**Applicant's Replacement to Data Responses Set 3A
(Nos. 186-190)
for the APPLICATION FOR CERTIFICATION
for the Rio Mesa Solar Electric Generating Facility
(Rio Mesa SEGF)**

(11-AFC-04)

Subject: Applicant's Replacement Data Responses Set 3A (Nos. 186-190)
Rio Mesa Solar Electric Generating Facility (11-AFC-04)

**Applicant's Replacement Response to Data Requests, Set 3A
(Nos. 186-190)**

**34TH AVENUE ACCESS ROAD
RIO MESA SOLAR
ELECTRIC GENERATING FACILITY**

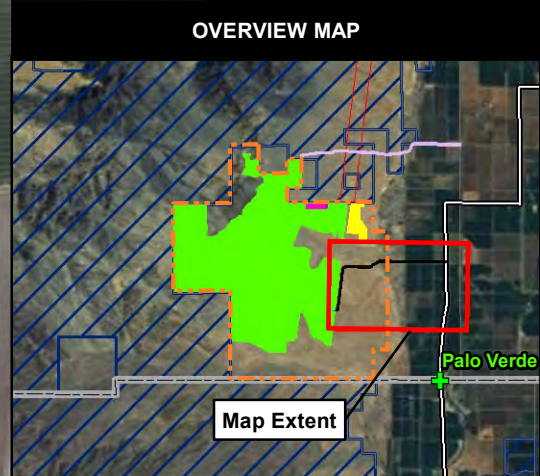
186. *Please provide a map of the proposed 34th Avenue access (secondary access) showing the exact location of the County ROW and any public or private easements, the location and type of any project access improvements, and property ownership (County, private, BLM, etc.) of the land on which improvements would occur. This map should commence at the connection of State Route 78 to its termination within the project site.*

The attached Figure 1 depicts the entire extent of the 34th Avenue access road improvements, from the connection at State Route 78 to the termination within the project site. The entire access road will be located on private lands. There are no existing easements along the access road through Section 24, Township 8 South, Range 21 East. The Riverside County, 60-foot wide right-of-way (ROW) ends at the western Boundary of Section 24 and is located south of and abutting the proposed project access road ROW. The project access road will be constructed in accordance with applicable County road and safety standards.

Rio Mesa Solar Project Primary Road Access: 30th Ave / Bradshaw Trail

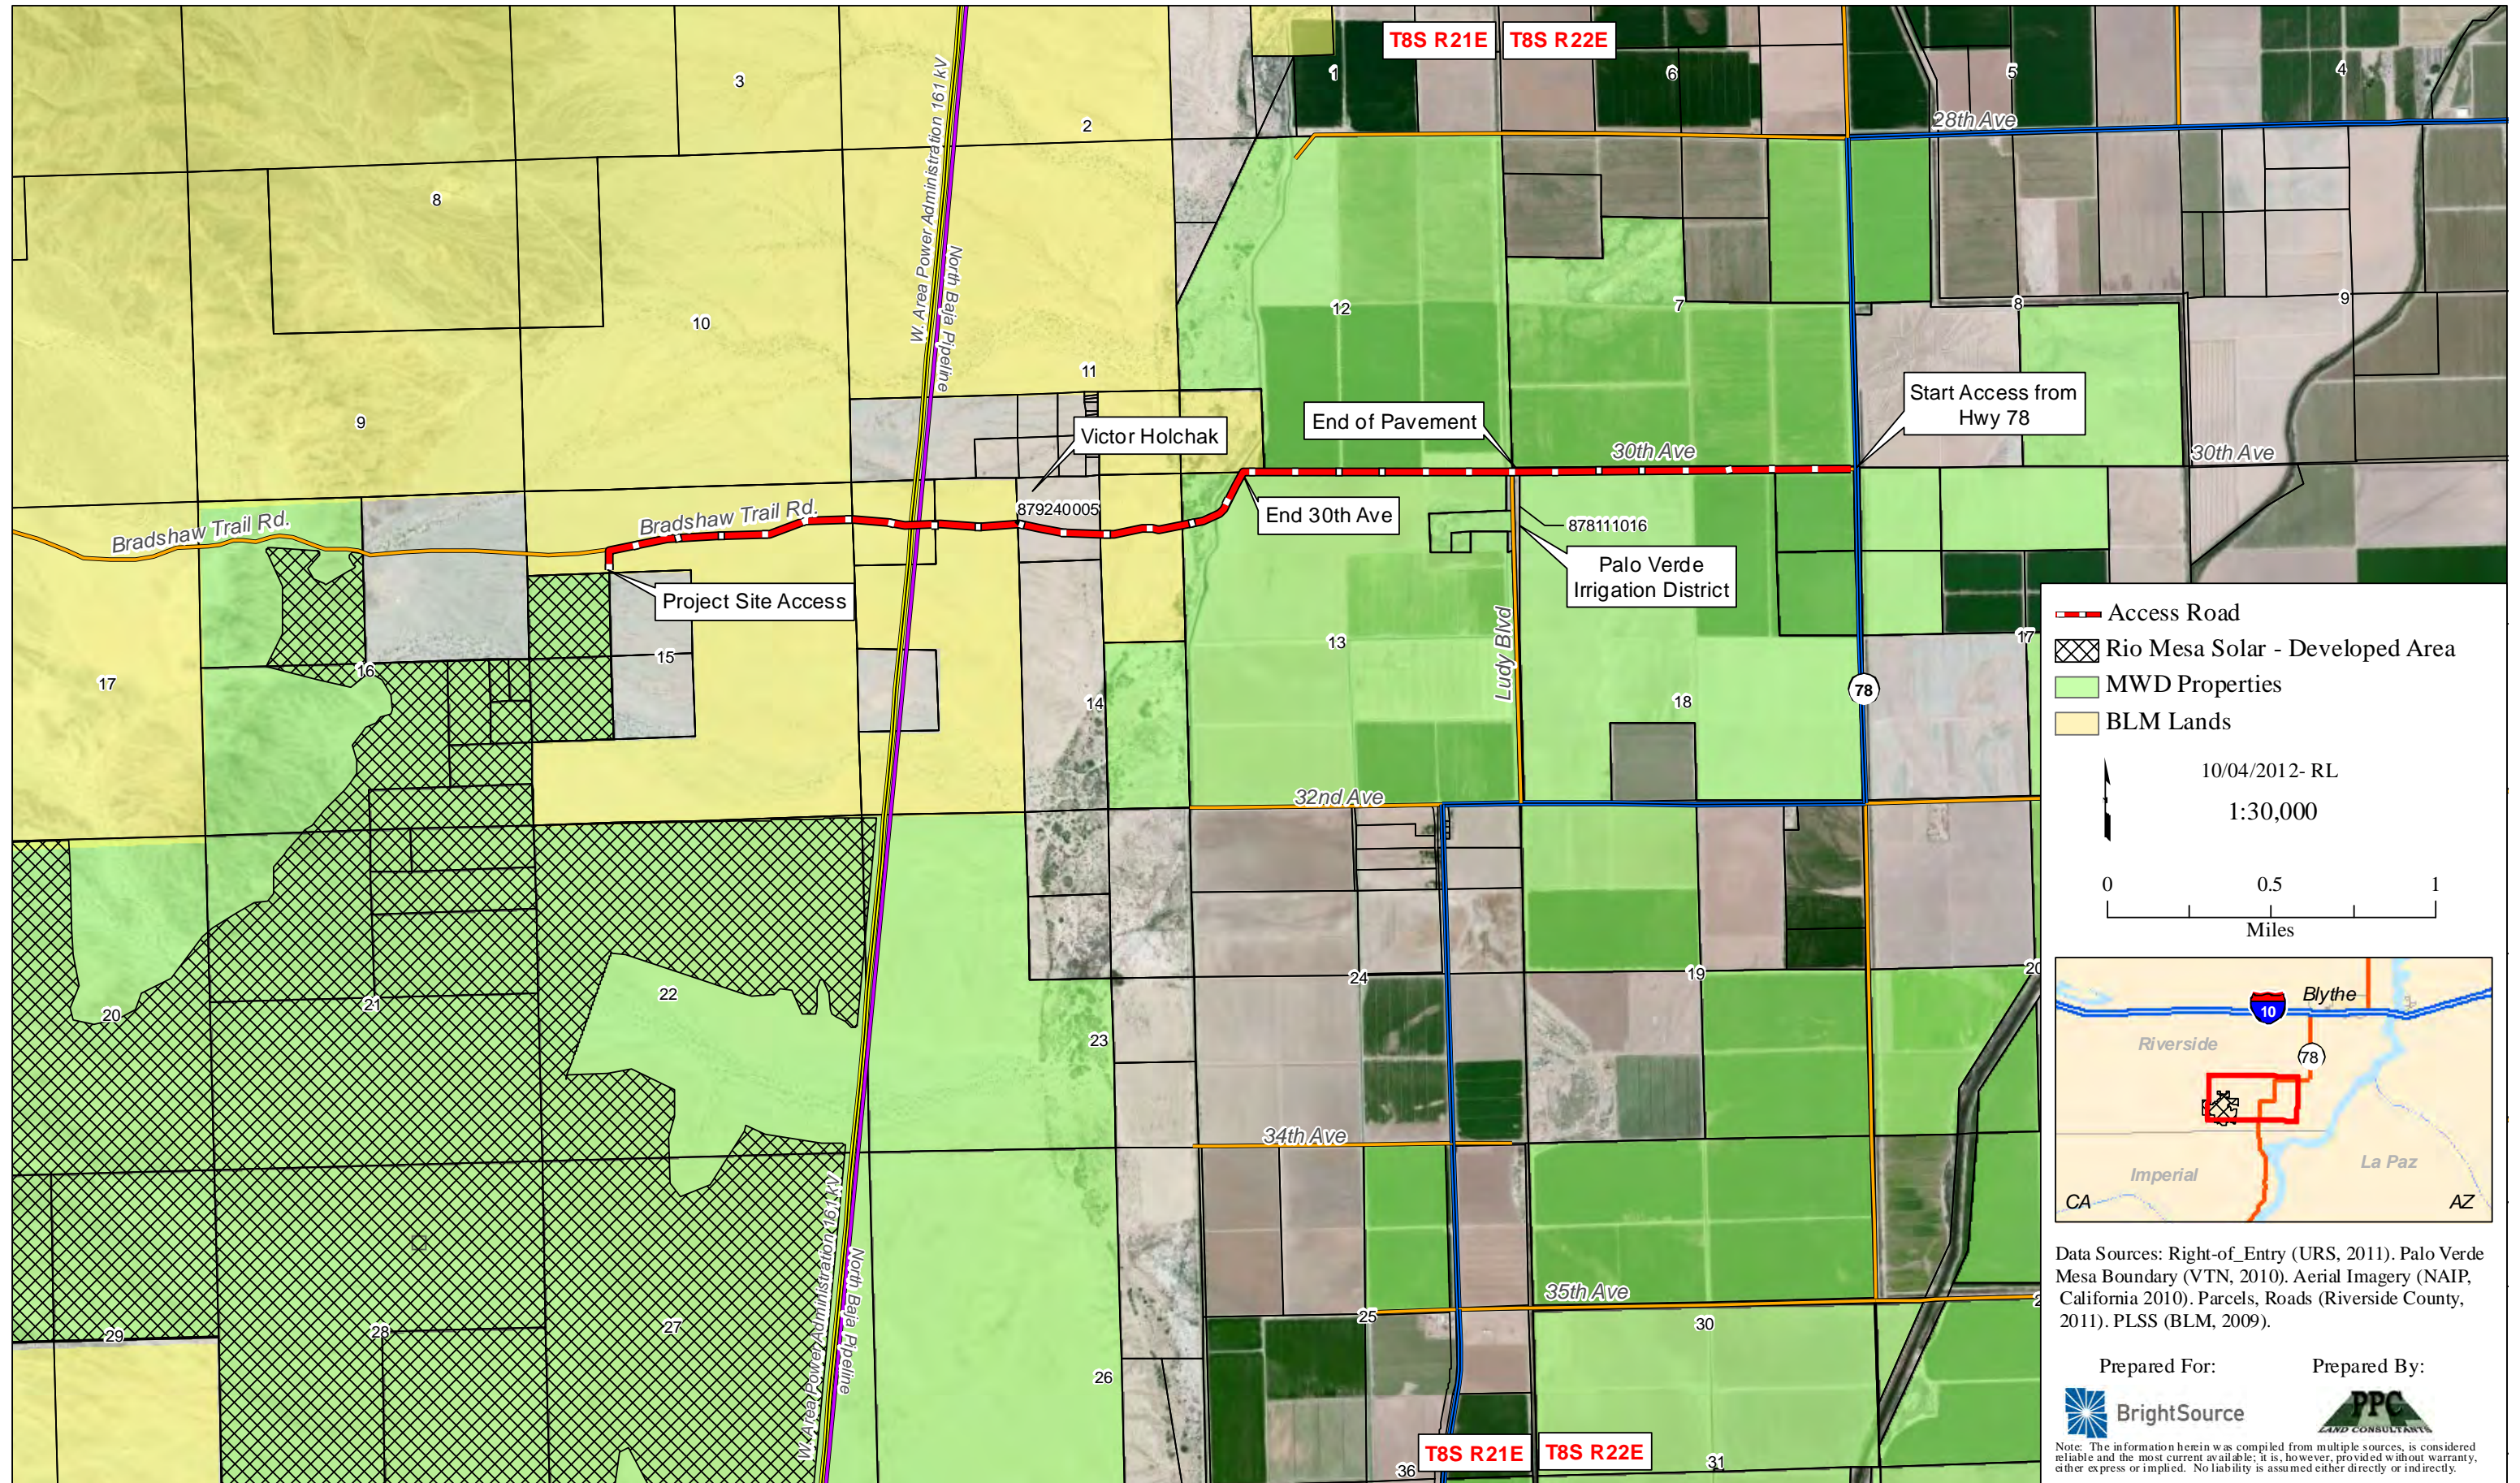
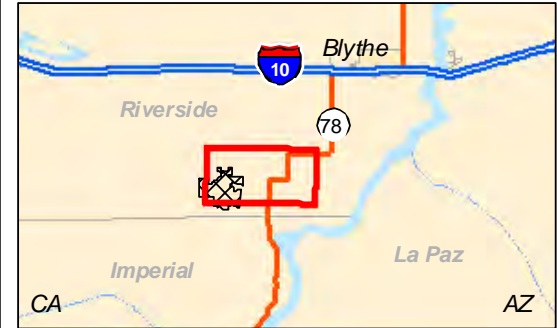
187. *Please provide a map of the 30th Avenue/Bradshaw Trail access showing the exact location of the County ROW and any public or private easements, the location and type of any project access improvements, and property ownership (County, private, BLM, etc.) of the land on which improvements would occur. Indicate on the map the portion of the road proposed to be paved. Also, indicate whether any agricultural lands would be impacted and if so, indicate by Prime Farmland and Farmland of Statewide Importance.*

Per Figure 2, attached, the Applicant intends to utilize 30th Avenue/Bradshaw Trail as its primary access, from State Route 78 (SR 78) westerly to a point which is approximately 3.85 miles west of SR 78 and 400 feet north of the project boundary. From that point, an access spur road will be built which runs south for approximately 400 feet until it enters the Project. While Riverside County does not hold a recorded ROW in the form of a dedication and acceptance, it maintains the above-described portion of 30th Avenue/Bradshaw Trail. Such maintenance is confirmed in Riverside County's Transportation Department Road Maintenance Book, and is recognized by the BLM. The County currently maintains this road to a width of 80 feet. The road is maintained in a paved state for a distance of 1 mile from SR 78 westerly to Ludy Boulevard. Continuing west from Ludy Boulevard for a distance of approximately 2.85 miles, the County maintains the road in an unpaved state. The Applicant proposes to pave the entire portion of its primary access lying west of Ludy Boulevard, so that the entire primary access from SR 78 to the project boundary is paved.

30th Avenue/Bradshaw Trail from SR 78 to a point which is 1 mile east of that intersection crosses agricultural lands owned by Metropolitan Water District of Southern California. These lands are not designated as Prime Farmland or Farmland of Statewide Importance. From that point west to the access spur road running south into the pProject, 30th Avenue/Bradshaw Trail crosses BLM lands and a 40-acre private parcel owned by Victor Holchak (the northeast [NE] ¼ of the NE ¼ of Section 14, Township 8 North, Range 21 East). Mr. Holchak's parcel is unimproved, non-irrigated desert, and is not designated as Prime Farmland or Farmland of Statewide Importance. The access spur road running south from 30th Avenue into the project site crosses BLM land before it enters the project boundary. The Applicant has applied to the BLM for a Grant of ROW for the segments of the access route that cross BLM lands.
